Important Notices

Restriction on Use of 8-bit Timers

Datasheet Modifications: PWM Cycle of 8-bit Timers

Example when using PWM mode

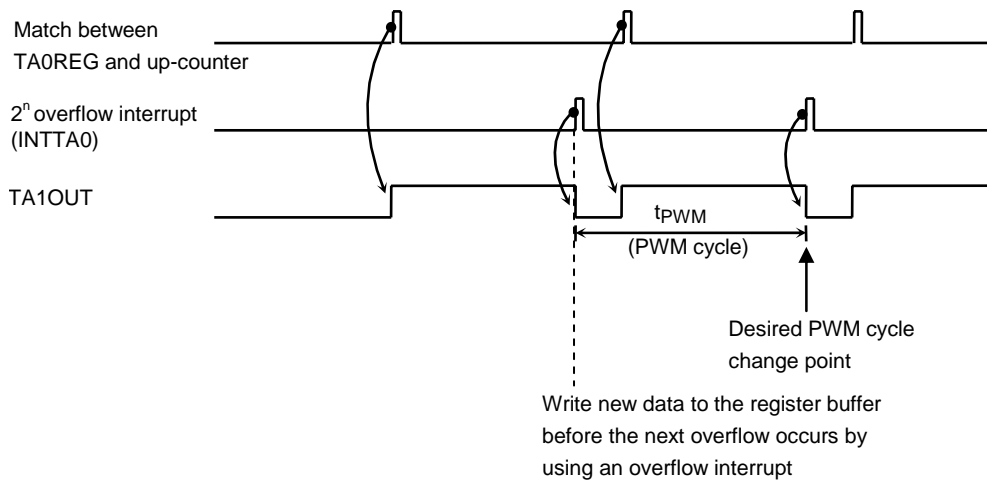
When the double buffer is enabled for an 8-bit timer in PWM or PPG mode, caution is required as explained below.

If new data is written to the register buffer immediately before an overflow occurs by a match between the timer register value and the up-counter value, the timer flip-flop may output an unexpected value.

For this reason, make sure that in PWM mode new data is written to the register buffer by six cycles ($f_{sys} \times 6$) before the next overflow occurs by using an overflow interrupt.

In the case of using PPG mode, make sure that new data is written to the register buffer by six cycles before the next cycle compare match occurs by using a cycle compare match interrupt.
